Shop Drawing Submittal Review

Project Name: Webster University-**ISB**

Copies	No.	Description
1 PDF	224216P02	(Submittal No.'s)
		(Cannon #22 4216.16-001) - (Paric #15051-) - (WES #607)
		➤ Commercial Sinks
		• Clinical Service Sink CSS-1
		• Scrub Sink SS-1
		• Sink SK-1
		• Garbage Disposer GD-1
		• Sink SK-2
		• Sink SK-3
		• Mop Sink MS-1
		• Kitchen Sinks KS-1, KS-2, KS-3

SPEC SECTION: 22 4216.16
Commercial Sinks

PFPTB100/200/300/400 Series**Adjustable Tubular P-Traps****PFPTB101**

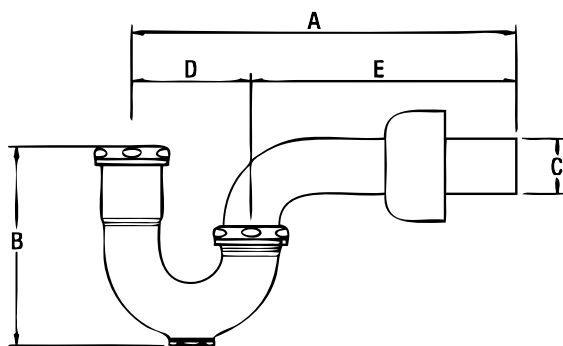
1-1/2 SEMI CAST P TRAP W/CO CP

5/8" OD CP SHALLOW ESC FLANGE

1. Provide under counter waste and supply protective piping covers as required.
Verify requirements with the architectural drawings.
2. Escutcheons are specified to be cast brass. Refer to specification section 220518.
